FOONLY, INC.		23-DEC-79 15:01	
		CFDACN.DRW (4,41)	
DRAWN BY:	PAGE	OF	NUMBER /
APPROVED BY:	PROJECT:		REV.

CFTA-4
BUG FIXES: (shown in red)
CFTCMA
CFT FCT
CFT I1

FOONLY, INC.		16-MAY-80 02:15	
DRAWN BY:		CFTACN.DRW (5157,4622)	
APPROVED BY:		REV.	
PAGE	OF	NUMBER	
PROJECT:		<i>CFTA-4</i>	
		<i>MASTER COPY</i>

FOONLY INCORPORATED		23-DEC-79 15:27	
DRAWN BY:		UWAIT.DRW (4, 41)	
APPROVED BY:		PAGE 1 OF 1	NUMBER 8
PROJECT:		REV.

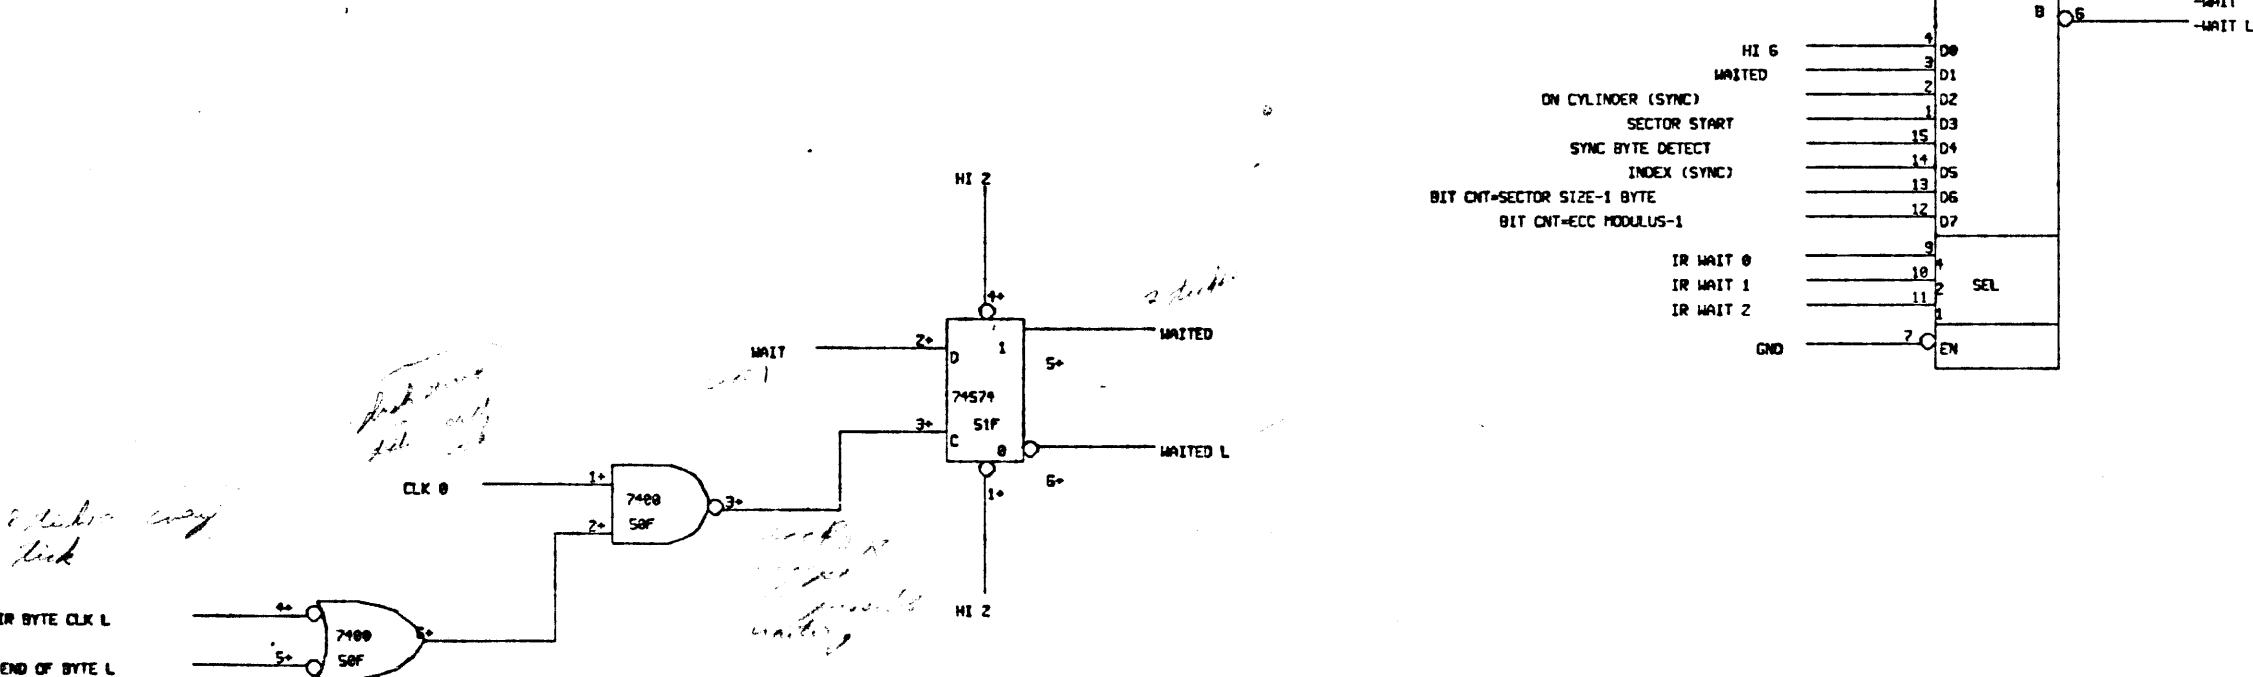
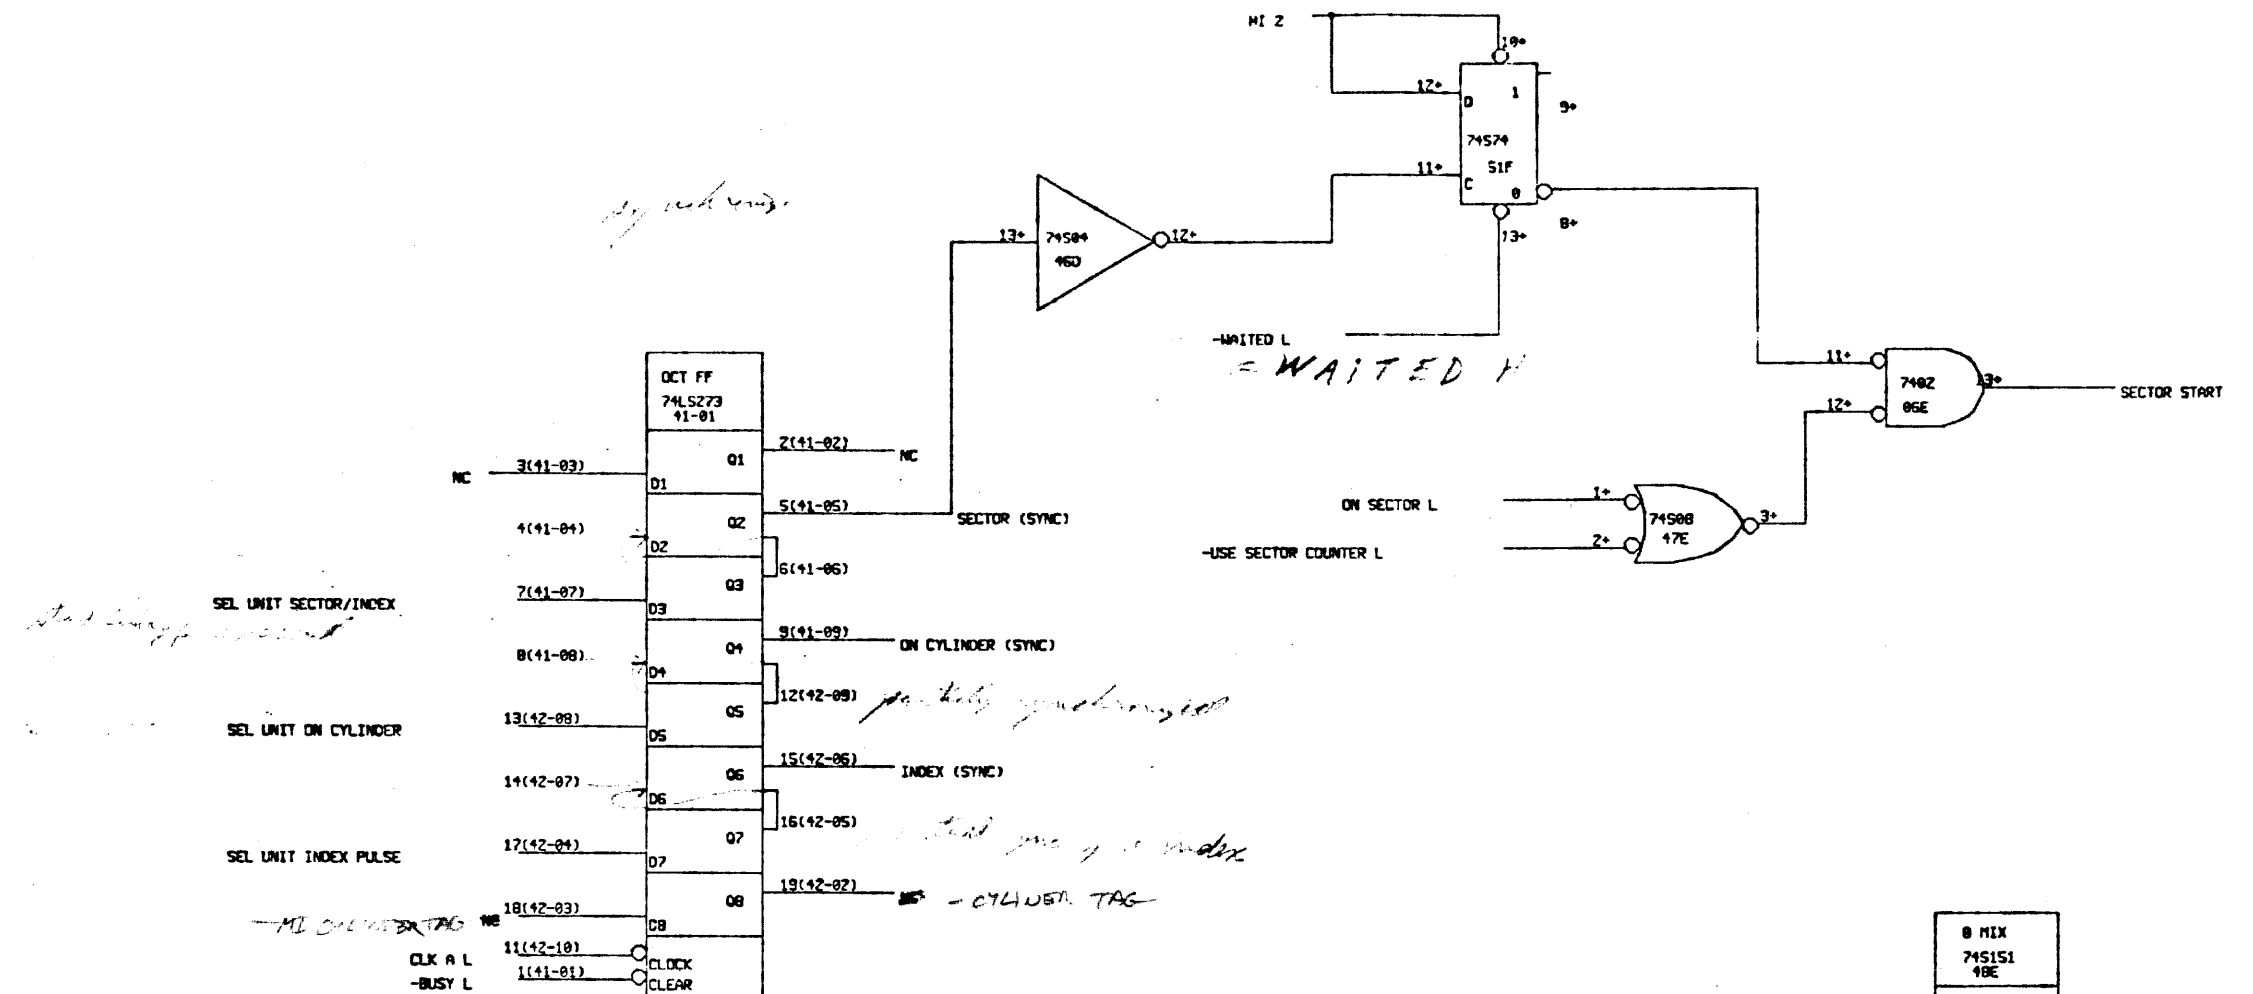
- Top center: *sync*
- Left side: *Start timing circuit*
- Right side: *partially unacknowledged*
- Right side: *used for index*
- Right side: *- CYLINDER TAG*
- Bottom left: *Handwritten note about CLK 0 and END OF BYTE L*
- Bottom center: *Handwritten note about WAIT and WAITED L*

FOONLY INCORPORATED		28-DEC-79 05:49	
		ERRORS.DRW (4, 41)	
DRAWN BY:	PAGE 1 OF 1	NUMBER 6	REV.
APPROVED BY:	PROJECT:

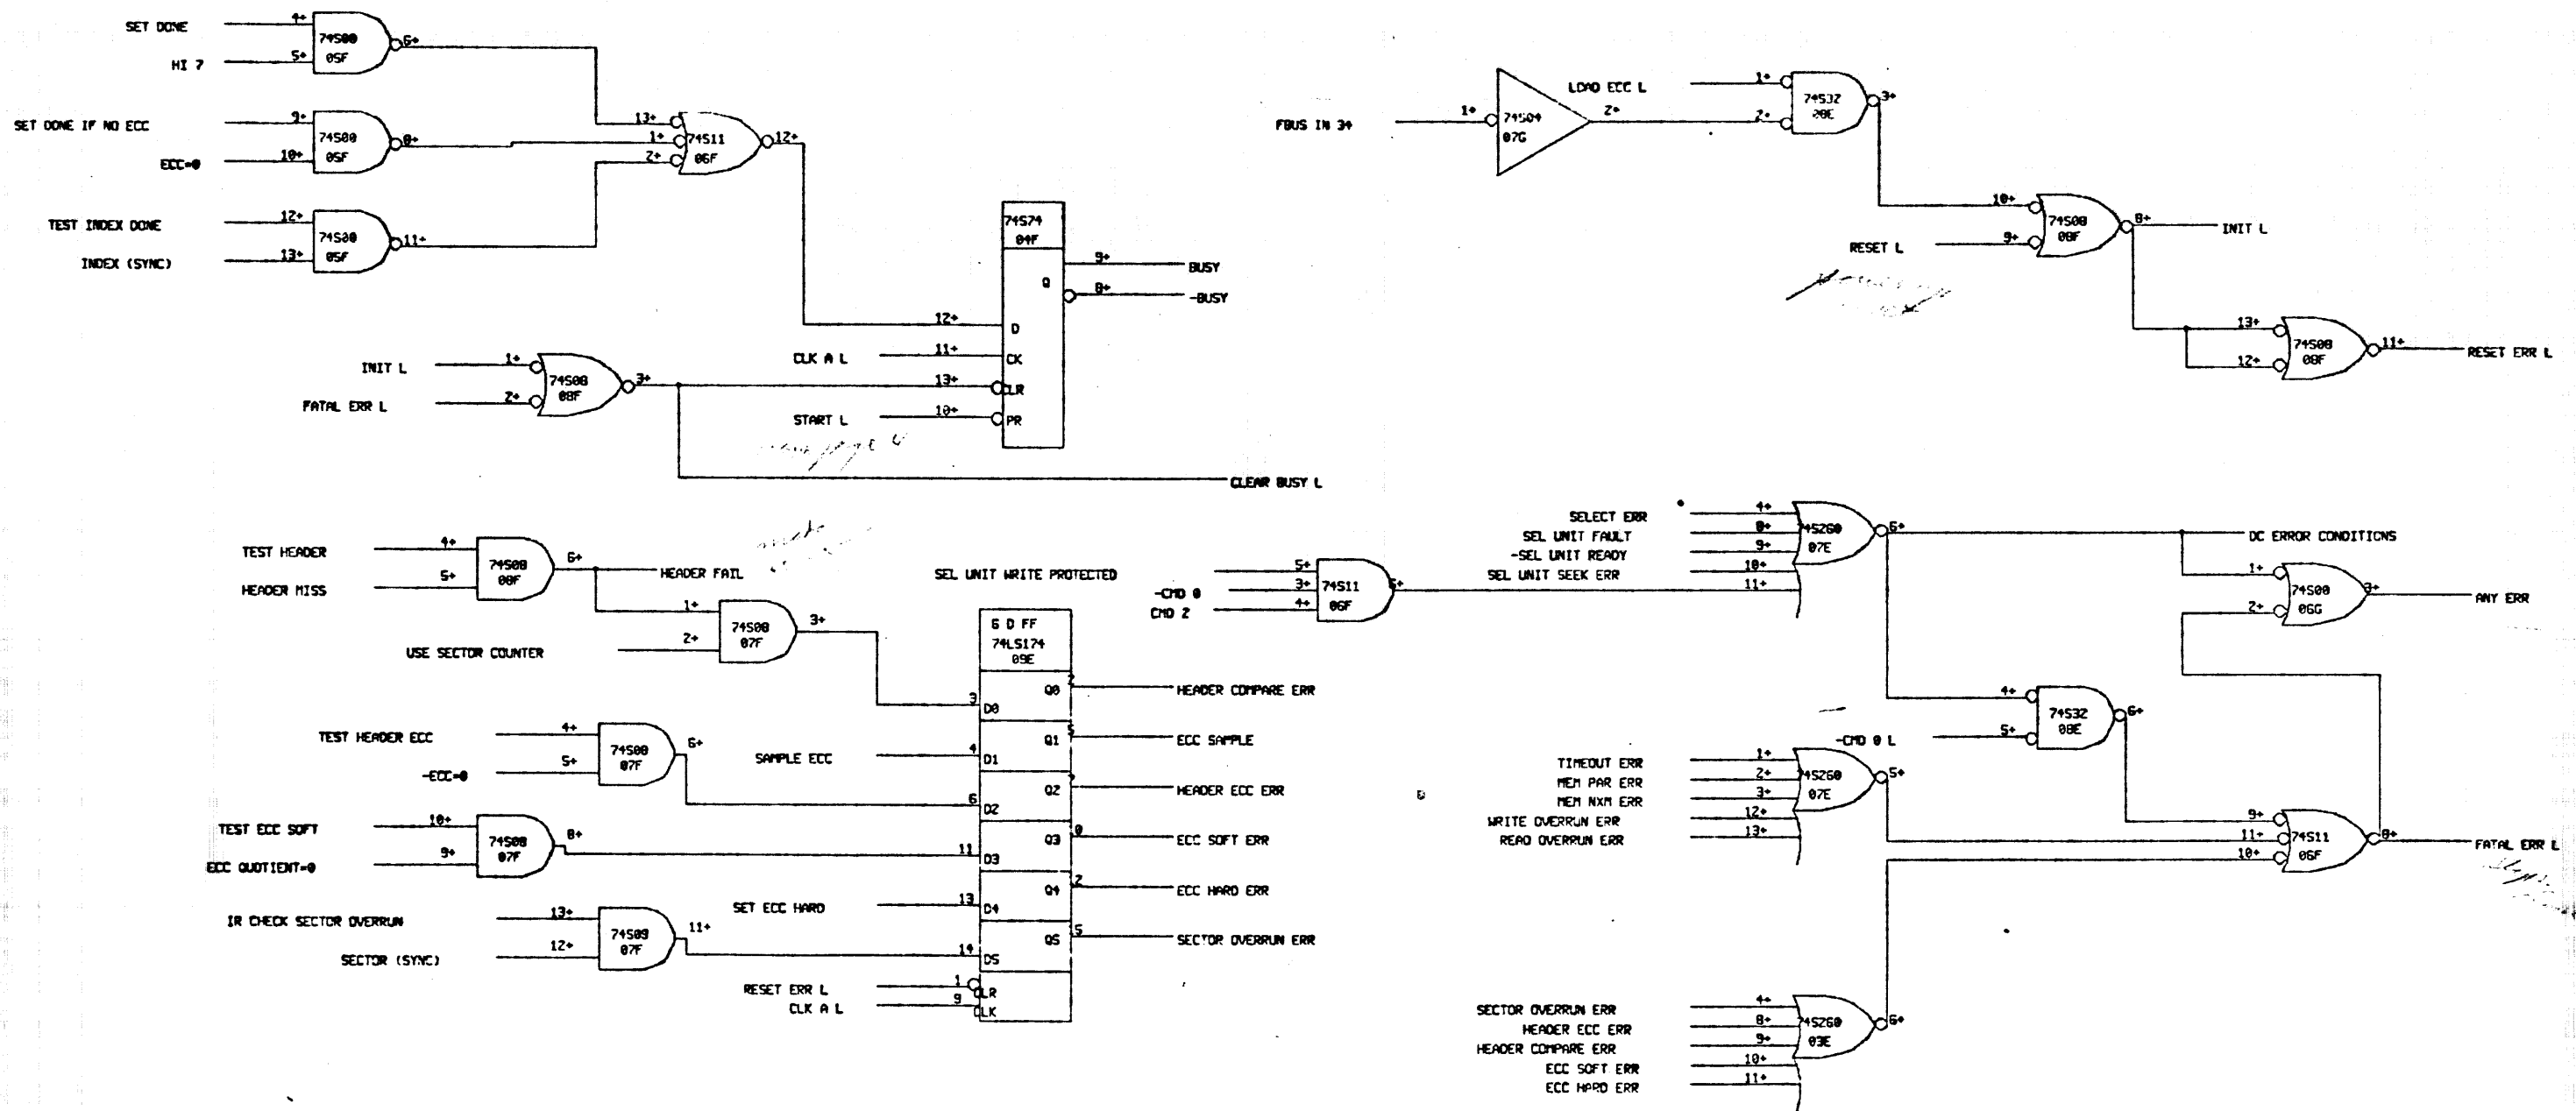
Handwritten note: The error codes are all from the 74511.
